FINAL GENERIC ENVIRONMENTAL IMPACT STATEMENT

Long Island Jewish Medical Center Modernization Program

Date Final GEIS accepted as complete: June 2, 2009

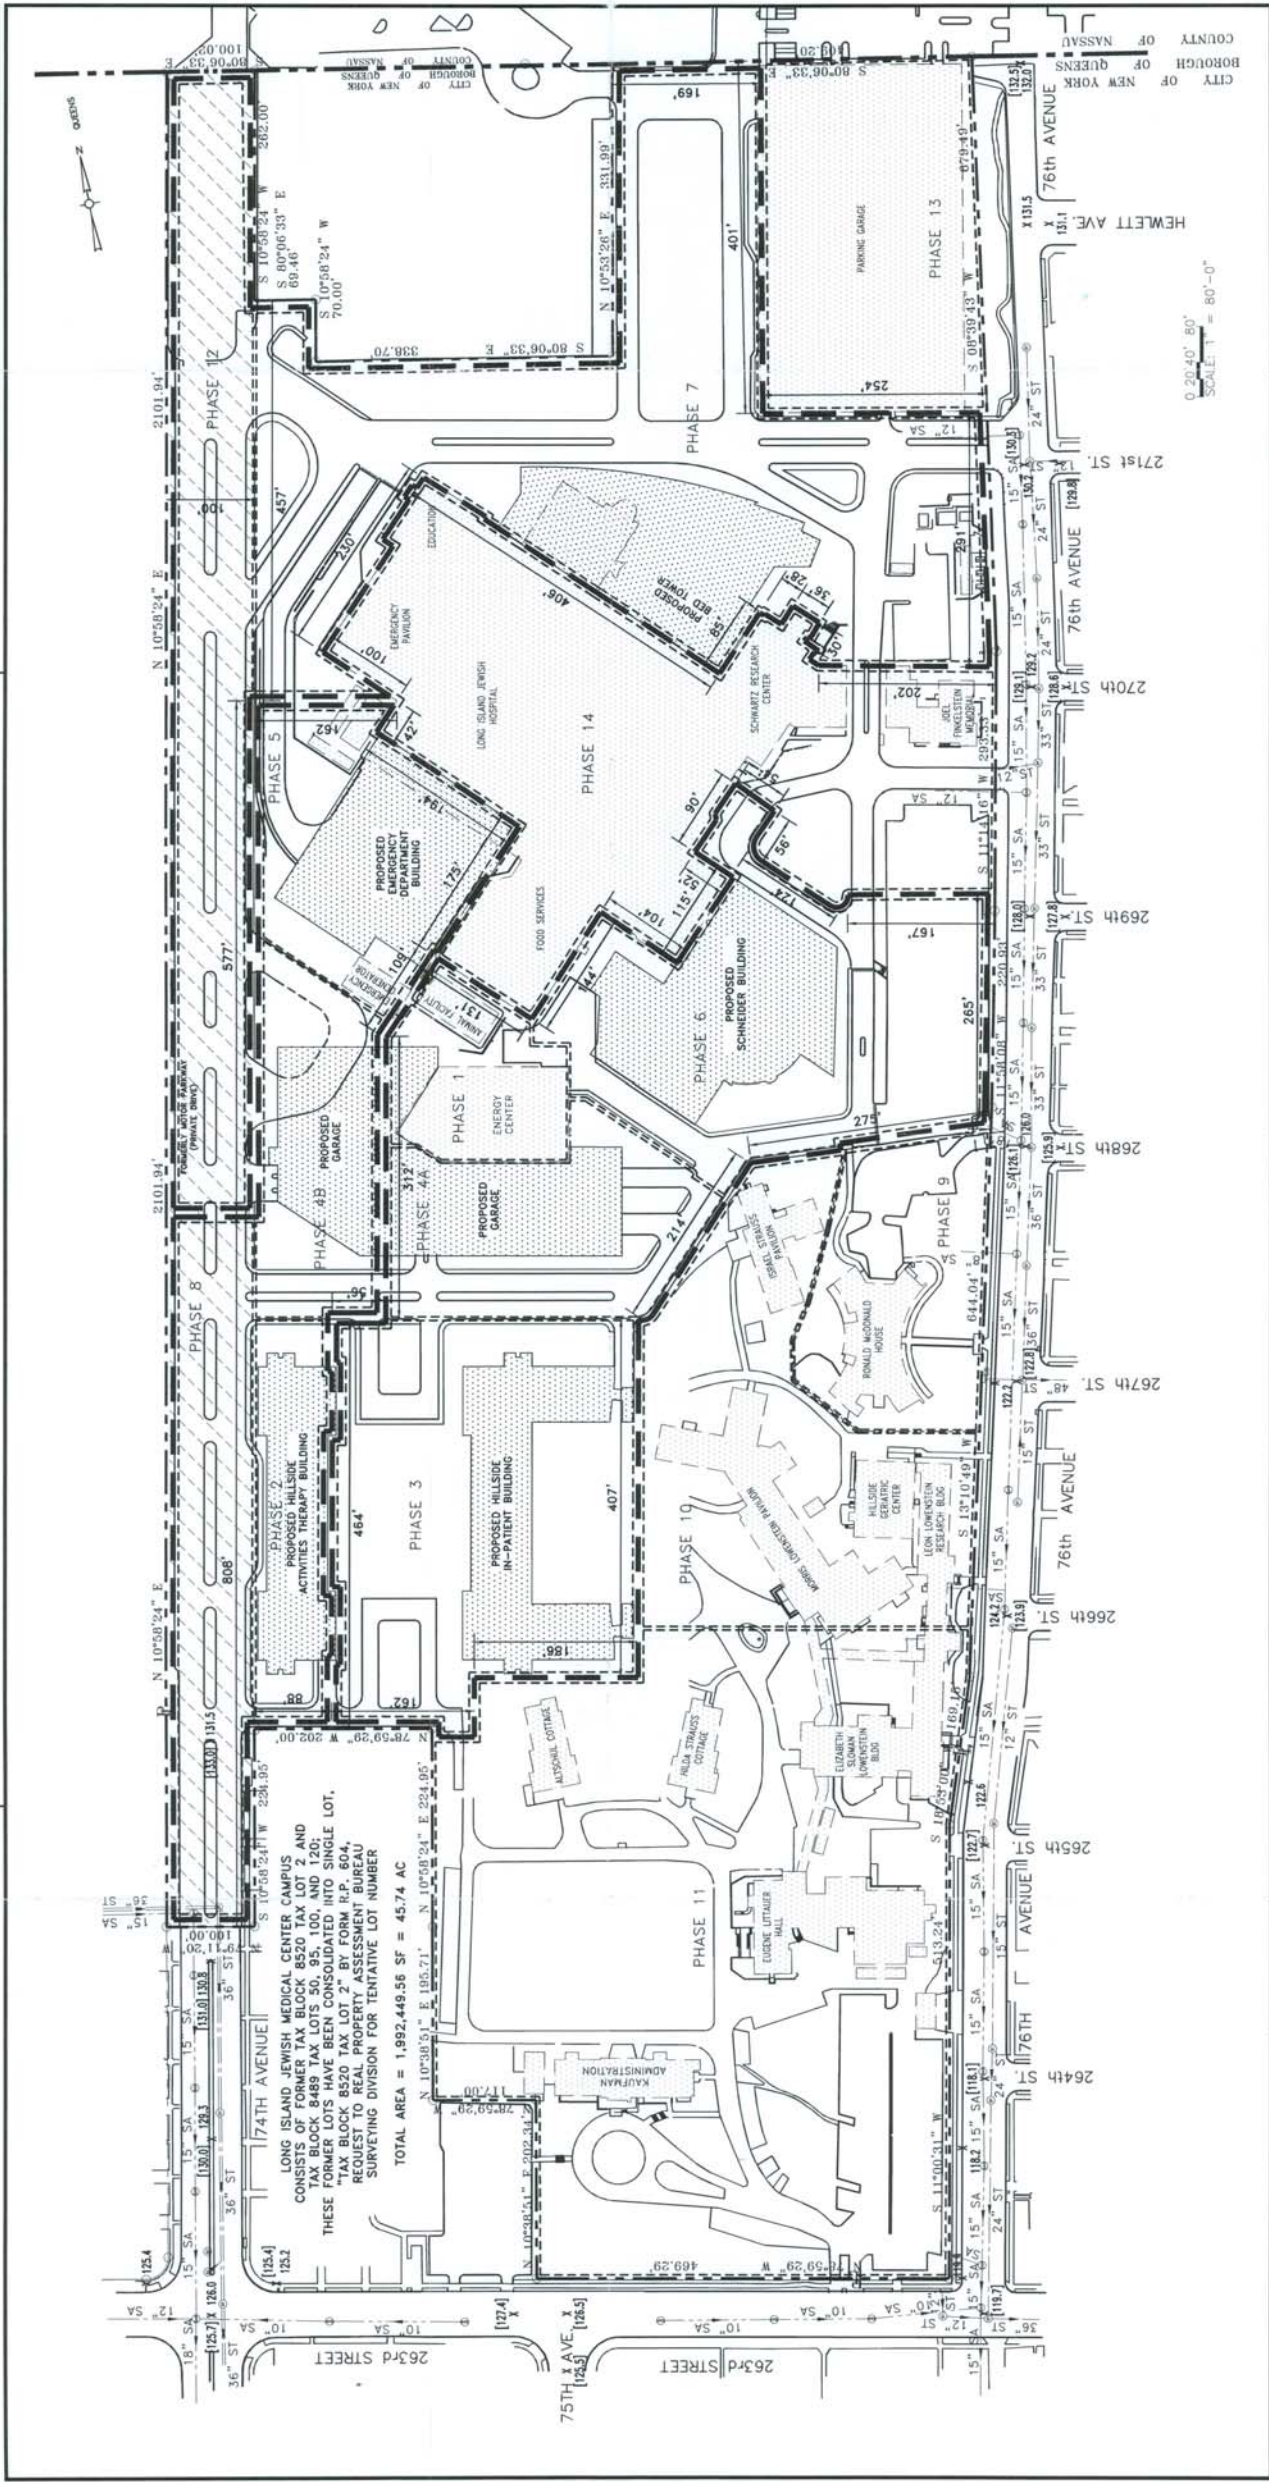
6. There are no data to support the estimate that the proposed action would result in an additional 100,000 gallons per day of water usage and sanitary sewage generation. On page 13-3 of the DGEIS, there is reference to a "Master Drainage Plan SCQ 050/03," however, this document is not included in the DGEIS (it was not in the copy provided to the Village).

Sanitary Sewage. Under the *Master Drainage Plan SCQ 050/03*, the anticipated increase in sanitary sewage generated by the Proposed Project would be approximately 100,000 gpd. A new sanitary site connection into the existing 15-inch sanitary line under 76th Avenue would be constructed to support the new Women’s Hospital Project. The other elements of the Proposed Project would not require any new sanitary site connections as the existing infrastructure to support the new facilities is already in place. Overall, this increase in sewage would result in a small addition with total site usage becoming approximately 0.1 percent of the 100 million-gpd design capacity of the Jamaica WPCP which serves the site.
